Access Compliance Report

Public Rights-of-Way

(Curb Ramps)

Intersection ID: 3274	Main Street: MALLARD_GREEN_PL	Cross Street: SHELLY_PINES_DR	Location: W
ADA ID: D42261809782	Ramp Type: Perp	Initial Pass/Fail: Fail	Overall Compliance: No
Severity Score: 22.5			
Codes/Mitigation Info/Possible Solution		Field Measurements/Component Compliance

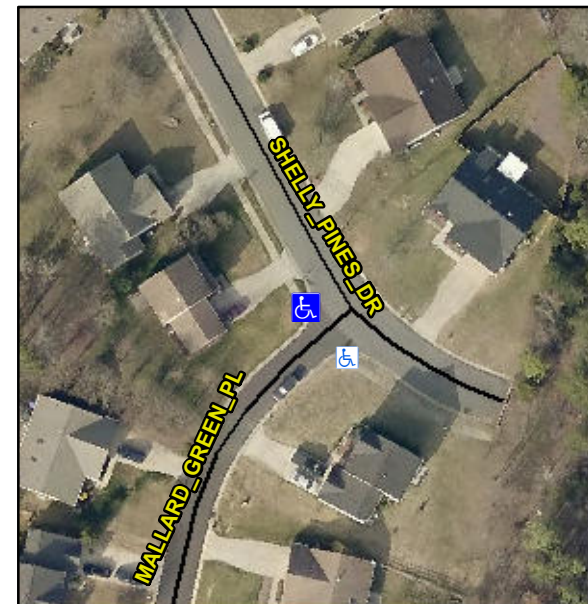
Not Found, R304.5.1, R304.2.2, R304.5.3

Compliance	Description	Data	Compliance	Description	Data
N/A	Ramp Length (in)	47.5	No	Ramp Slope (%)	9.0
No	Ramp Width (in)	43.0	No	Ramp XSlope (%)	3.5
N/A	Flare Type LT	N/A	N/A	Flare Type RT	N/A
N/A	Flare Slope LT (%)	N/A	N/A	Flare Slope RT (%)	N/A
N/A	Flare Traversable LT?	N/A	N/A	Flare Traversable RT?	N/A
N/A	Landing Length (in)	N/A	N/A	DWS Provided?	N/A
N/A	Landing Width (in)	N/A	N/A	DWS Contrast?	N/A
N/A	Landing Slope (%)	N/A	N/A	DWS Length (in)	N/A
N/A	Landing X Slope (%)	N/A	N/A	DWS Full Width?	N/A
N/A	Landing Curb? (Y/N)	N/A	N/A	DWS Offset (in)	N/A
N/A	Shared Landing?	N/A			
N/A	Gutter Ponding?	N/A	N/A	Gutter Slope (%)	N/A
N/A	Gutter Lip Ht (in)	N/A	N/A	Gutter X Slope (%)	N/A
N/A	Painted X Walk1?	No	N/A	Painted X Walk2?	N/A
	X Walk 1 Direction	To SE		X Walk 2 Direction	N/A
N/A	X Walk 1 Width (in)	N/A	N/A	X Walk 2 Width (in)	N/A
	X Walk 1 Slope (%)	3.8		X Walk 2 Slope (%)	N/A
	X Walk 1 X Slope (%)	4.0		X Walk 2 X Slope (%)	N/A

Remove & Replace Entire Ramp.
